**PRELIMINARY NOT FOR CONSTRUCTION**

**BLOOMINGTON LINCOLN**  
 1001 Clover Drive, Bloomington, MN

**SITE PLAN**

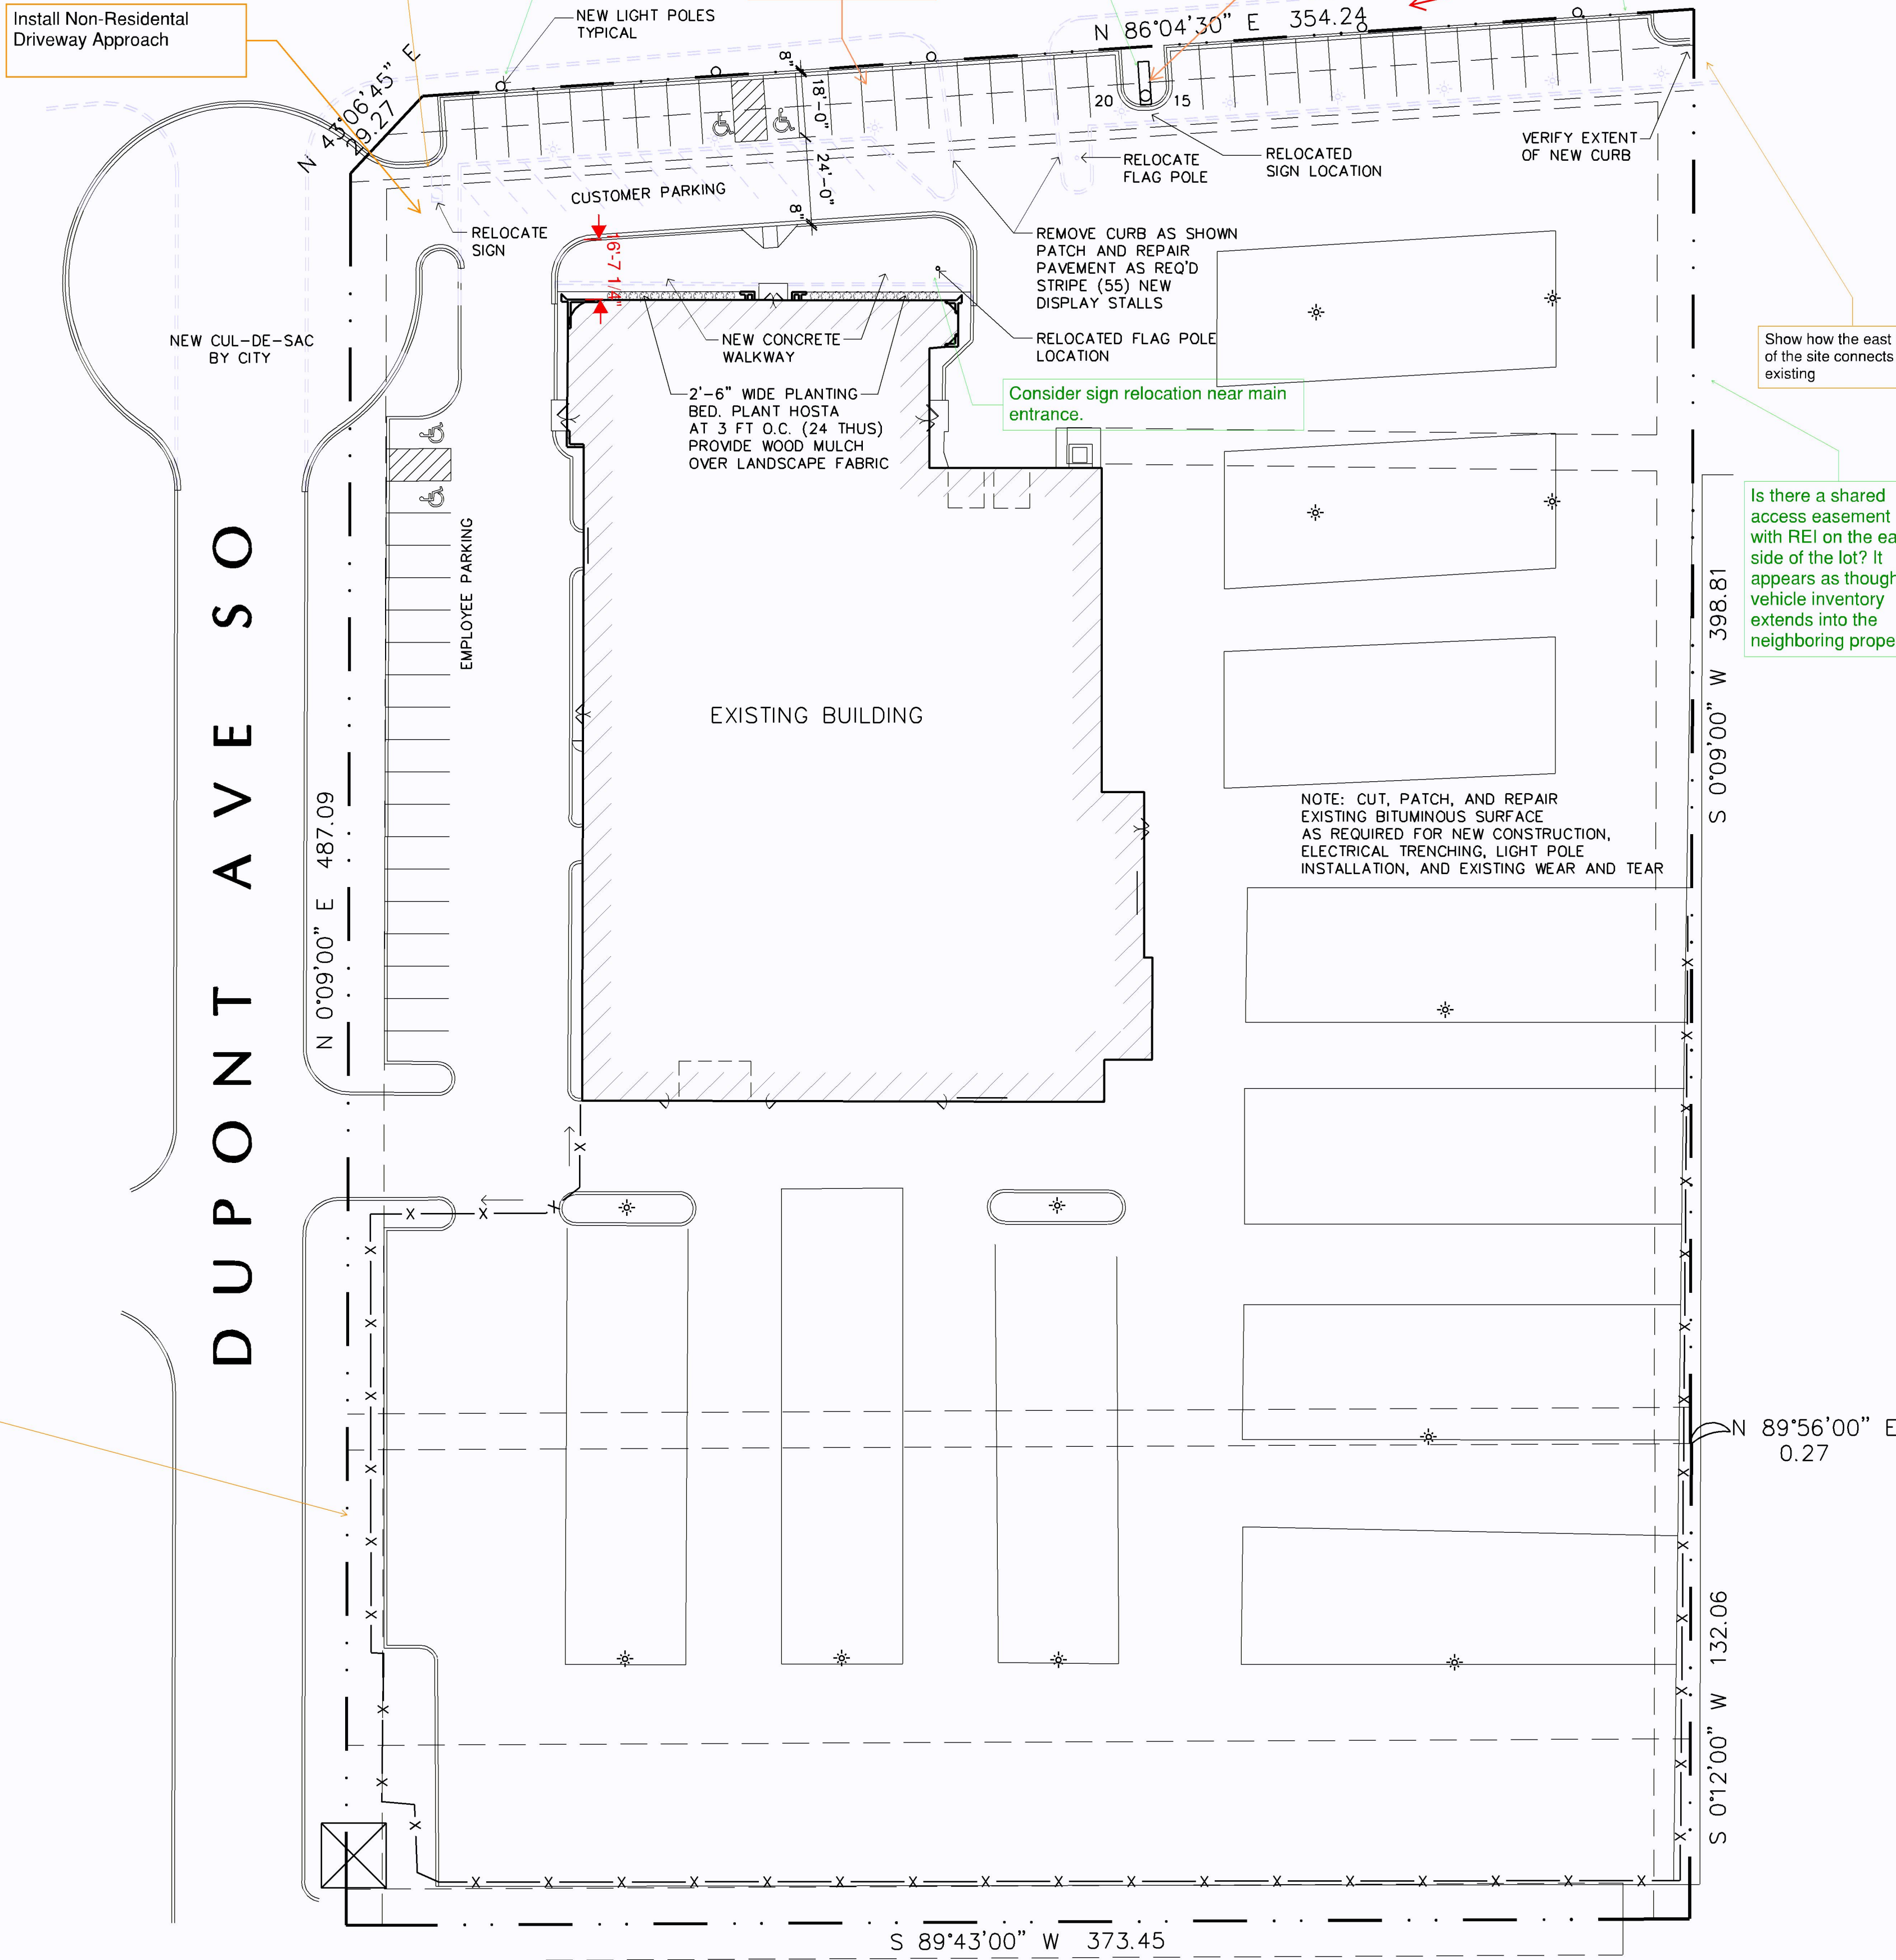
Maintain emergency vehicle access and circulation throughout the property.

Must meet 2020 MN State Building Code

Must meet 2020 MN Accessibility Code.

Provide required accessible stalls per 2020 MN State Accessibility code.

Per Section 1106.6 of 2020 MN Accessibility Code, Accessible parking spaces shall be located on the shortest accessible route of travel from adjacent parking to an accessible building entrance.

If ultimately seeking a variance for the setback, please be sure to address the variance findings of fact in the project summary:

Install Non-Residential Driveway Approach

Show driveway access as a 90 degree intersection with the cul-de-sac. There can be driveway flares (see non-residential driveway detail), but it should be designed as a driveway intersecting the cul-de-sac, not a continuous curve. As shown your drivers would not be able to distinguish a yield point.

Light poles must be installed entirely on private property.

Freestanding sign must meet minimum setback from north property boundary, given the existing 25-foot drainage and utility easement, the minimum setback is 25 feet.

A 0-foot setback is proposed. The minimum setback is 20-feet. An encroachment agreement would be required for a 20-foot setback given the existing 25-foot easement

Sign conflicts with sewer and water lines within 25' drainage and utility easement.

Hydrant to be relocated and/or accessible from the property.

Do not encroach into 10' Sidewalk easement.

Show how the east edge of the site connects to existing

Is there a shared access easement with REI on the east side of the lot? It appears as though vehicle inventory extends into the neighboring property.

Consider constructing sidewalk along Dupont Ave and add connection from sidewalk to building
